Notice of Project Change
Submitted Pursuant to Article 80 of the Boston Zoning Code

JACKSON SQUARE

JACKSON COMMONS PROJECT

**RE: Notice of Project Change
Jackson Square, Site II Phase 1
Boston, Massachusetts**

Figure 2. NPC Proposed Phase 1 Building Plan

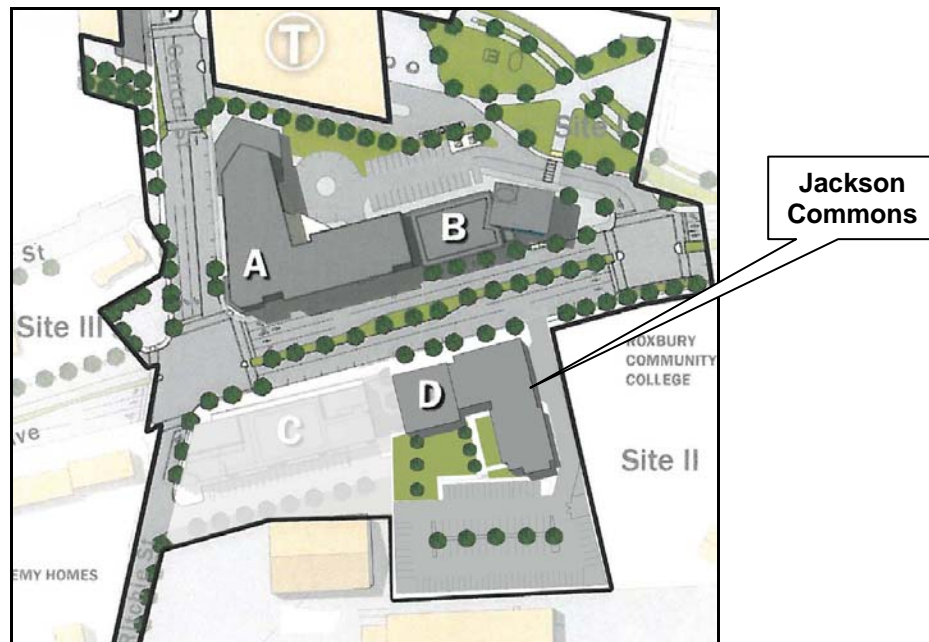
The original development program for Site II, Early Start/Phase 1 in Jackson Square, as outlined in the DPIR, included the development of 1542 Columbus Ave/Webb Building (Building “D”) into 13,500 sf of office space and a 13,400 sf DYS residential youth treatment facility (Building “F”). **Figure 1** below shows the Article 80 approved Phase 1 building plan.

The Site II, Phase 1 project, as revised, is now proposed to consist of 38 mixed-income residential rental units with ground floor use consisting of approximately 12,000 sf that will function as a Neighborhood Learning Center and include the Urban Edge office, classrooms, computer room, food pantry, and space for other non-profit led programs, and 3,500 sf of ground floor space associated with the residential units above including a property management office, resident resource coordinator office, laundry room, and a resident common room for residents of the building. **Figure 2** below shows the overall Phase 1 Building Plan which reflects the changes in this NPC.
